**TOWN OF EXETER
PLANNING DEPARTMENT MEMORANDUM**

1. Garrison Glen, LLC, 24 Continental Drive, Tax Map Parcel #56-3.1

**RE: PROPOSED SITE PLAN – FINAL SUBMISSION
24 CONTINENTAL DRIVE
EXETER, NEW HAMPSHIRE**

TRC COMMENTS FROM MEETING ON SEPTEMBER 7, 2017

SHORELAND PROTECTION DISTRICT AND WETLAND/BUFFER IMPACT PLAN
Proposed Multi-Tenant Light Industry/Distribution Facility
 24 CONTINENTAL DRIVE
 EXETER, NEW HAMPSHIRE

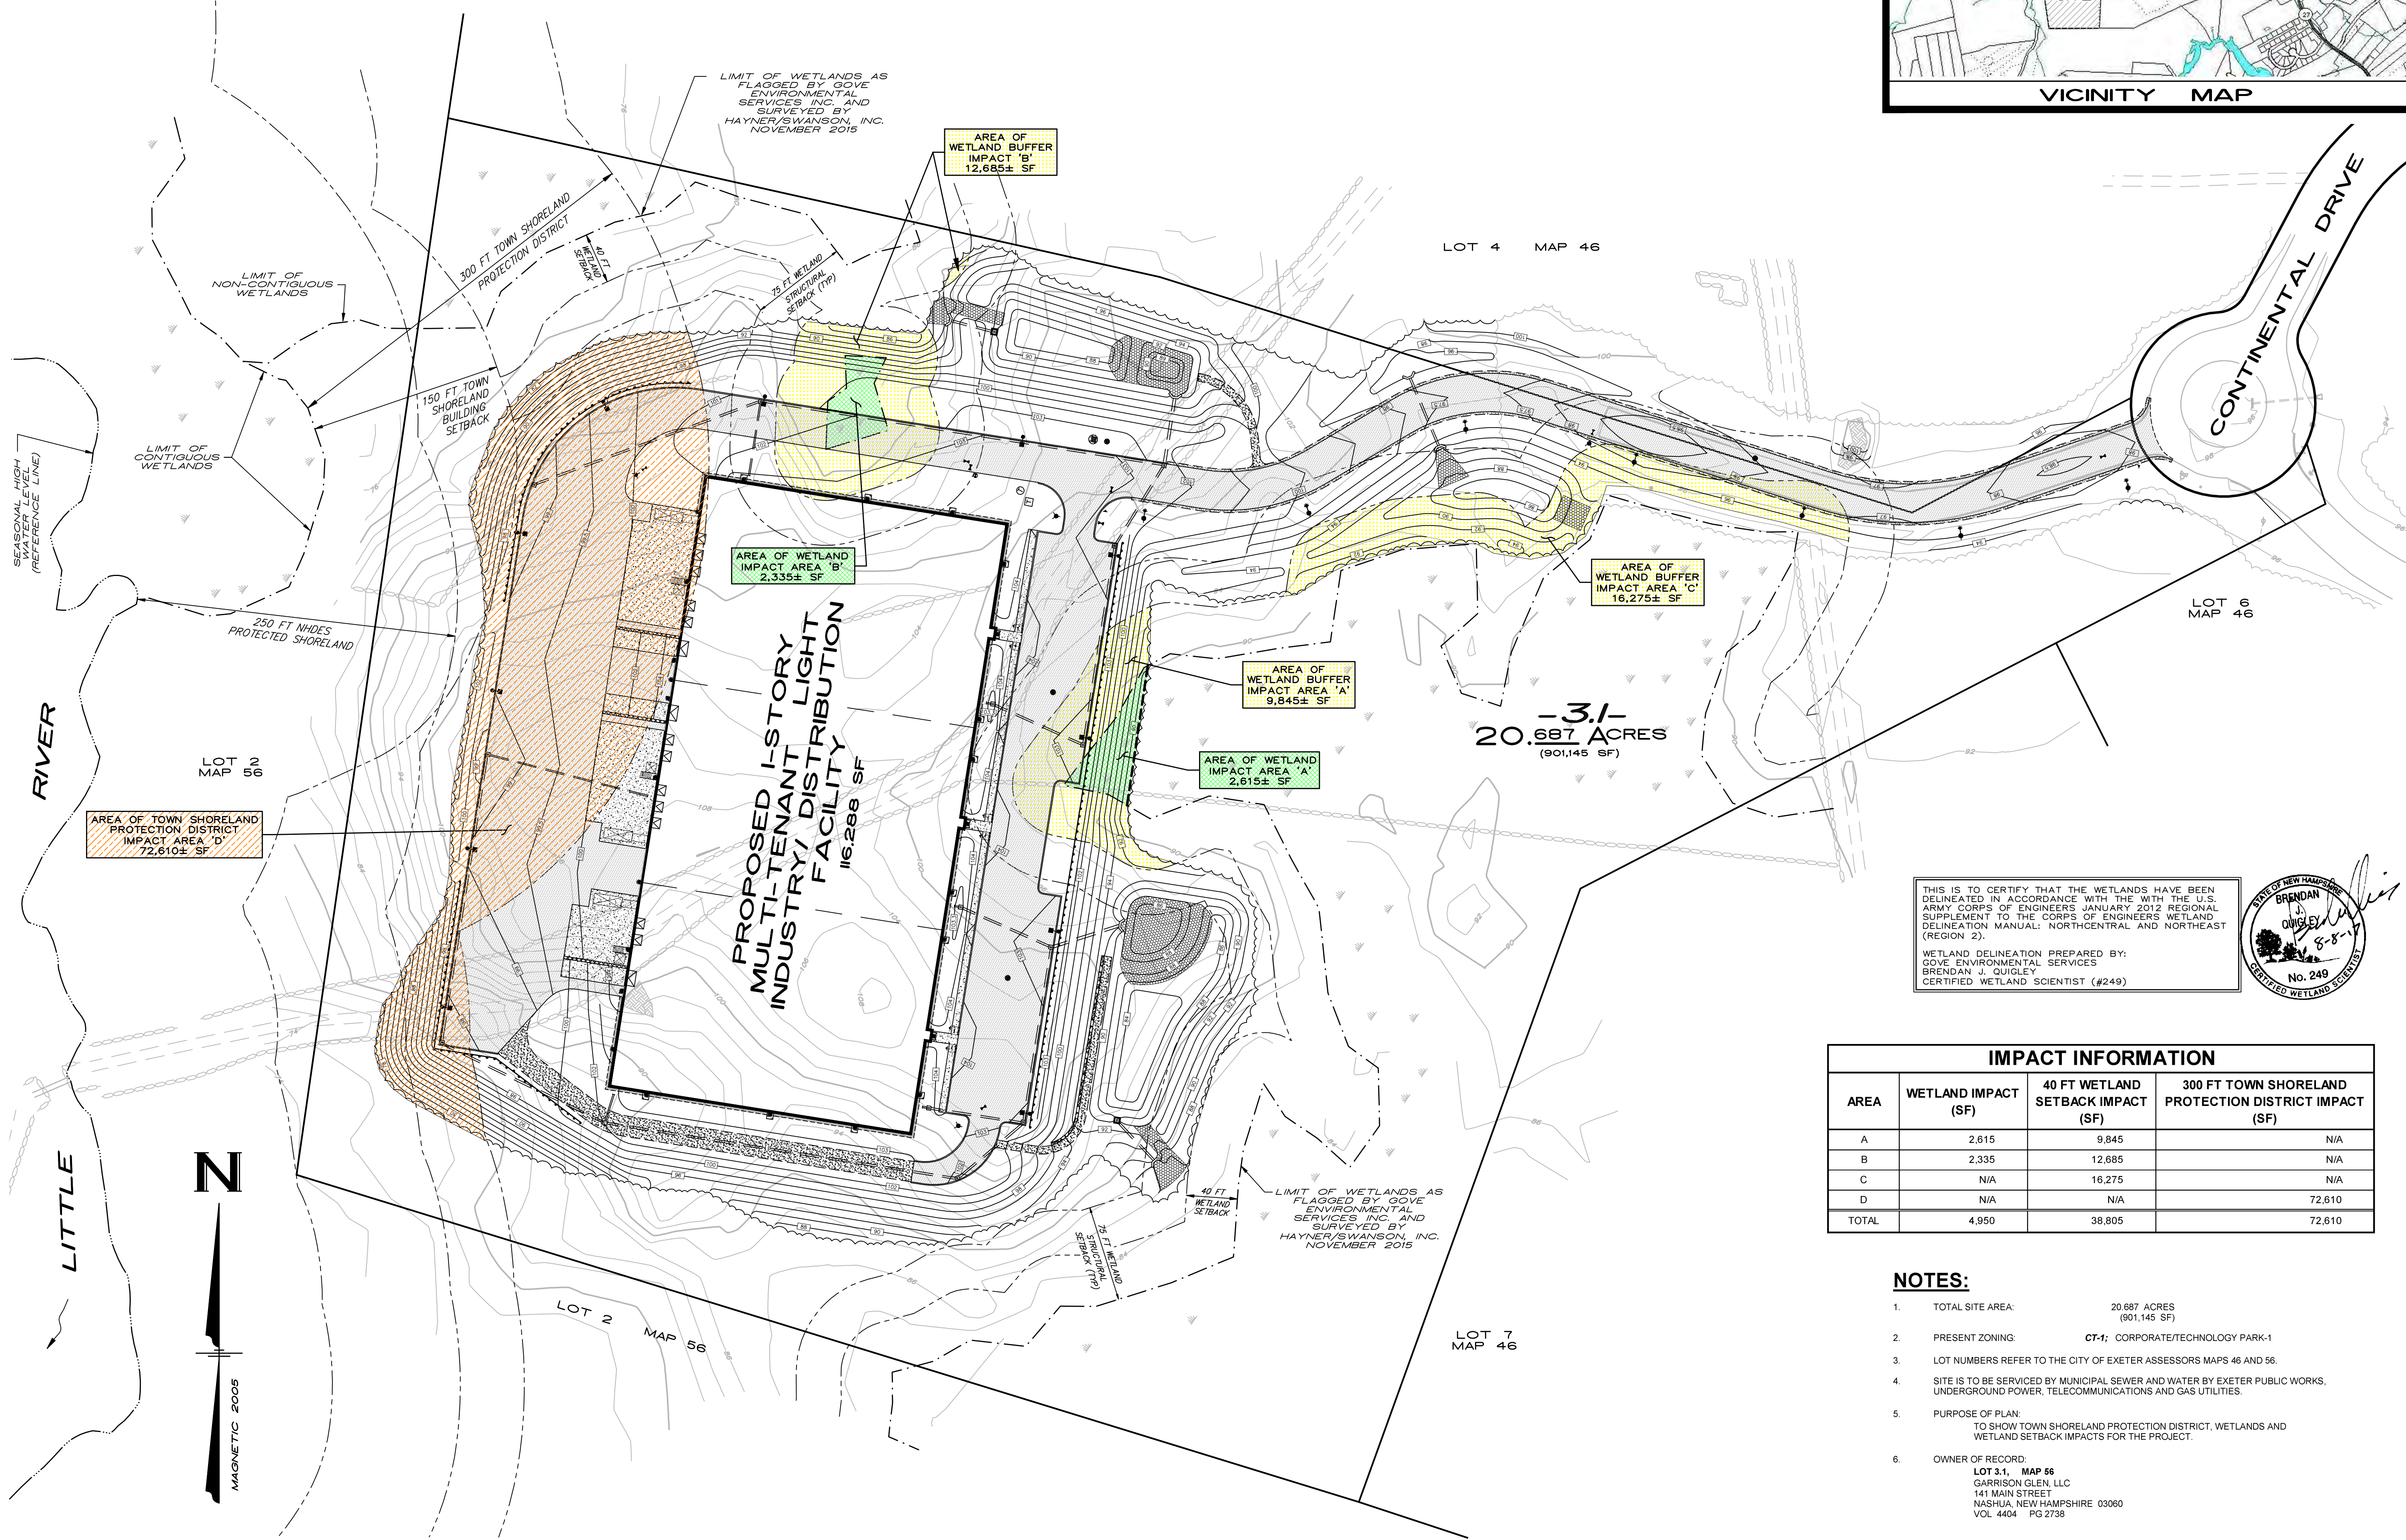
3. Contiguous Wetland: Is the wetland that is between this lot and Lot 4 contiguous with the Little River complex? Text states the wetlands planned for fill are not but does not speak to this wetland. If it is, please adjust buffer lines. If it is not I would recommend adding text to application to clarify. Also I didn't see a stamp from a wetland scientist on the plan. ***Wetlands on the property were flagged in 2015 by Gove Environmental Services and field located by Hayner/Swanson, Inc. All of the wetlands identified on the property are forested wetlands with poorly drained mineral soils, typical in New England and within the Continental Drive area. Though ultimately associated with the Little River, these wetland areas lie up gradient and distinctly separate from the river and its Contiguous Wetlands as defined by the Exeter Shoreland Protection District. The Contiguous Wetlands lie entirely off-site to the west within the Little River Conservation Area and are characterized by very poorly drained soils and a mixed scrub-shrub/emergent wetland type. The southern portion of the river in the project area is characterized by steep embankments which clearly define the seasonal high water with no adjacent wetland area. The limit of Contiguous Wetland, seasonal high water, and the associated limit of the 300-foot Town of Exeter***

- Shoreland Protection District is depicted on the plans. Also, the plans have been stamped by certified wetland and soil scientists.***
4. Please add label to buffer line that appears between the Town 300' and State 250' in NW corner of property. I believe it is 150' SPD but the symbol is the same as the 250' so it's difficult to distinguish. ***We have identified the buffer line in this location as requested.***

NO.	DATE	REVISION
1	11/29/17	REVISE WETLAND BUFFER IMPACT 'C'; UPDATE SITE PLAN
